Re: New Elk Mine
Permit C-1981-012
PR-5 Adequacy Response

New Elk Coal Company has the below responses to the previously submitted PR-5 Adequacy Review.

Figure 1: Screenshot showing records of constructed wells from DWR database with permit category "Residential" (pink dots) overlaid on proposed Map 1 and satellite image

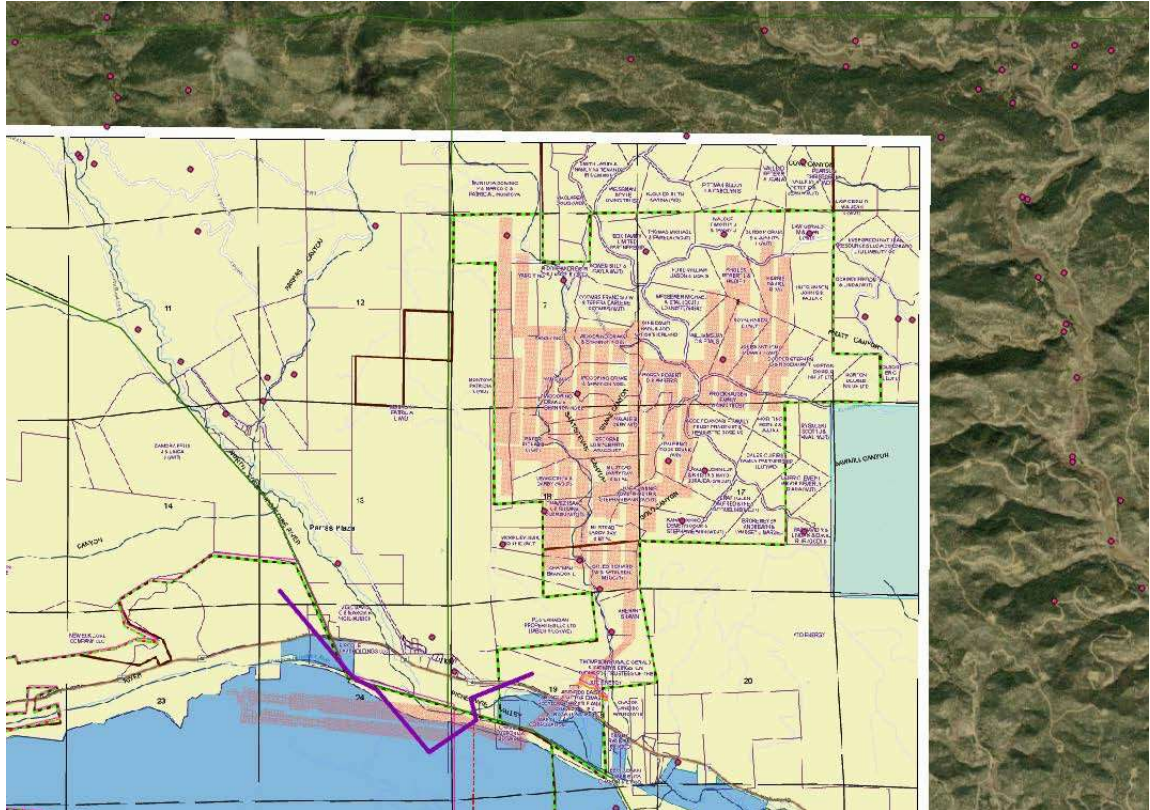
DRMS (Simmons) Comment: Minimal revisions have been proposed to section 2.04.7 of the PAP, however a complete description of the hydrology in the area of the mine is necessary before the consequences of mining can be assessed. It is clear at a cursory review that parts of section 2.04.7 are out of date (for example, Table 10 presents a groundwater user inventory, but the Colorado Division of Water Resources database contains many records of wells that have presumably not been included in the inventory, as is shown in Figure 1).

- a. **DRMS (Simmons) Response:** Please review section 2.04.7 of the PAP and update it as necessary given the expansion to the permit area proposed with PR-5.

NECC Response: Table 10 has been updated based on Colorado Division of Water Resources database search and Exhibit 11 has been updated with all the permitting documents. Map 8 has also been updated with new wells along with creating a map series (Map 8a through Map 8d) showing four detailed areas at a scale of 1" = 800' so it's easier to identify features.
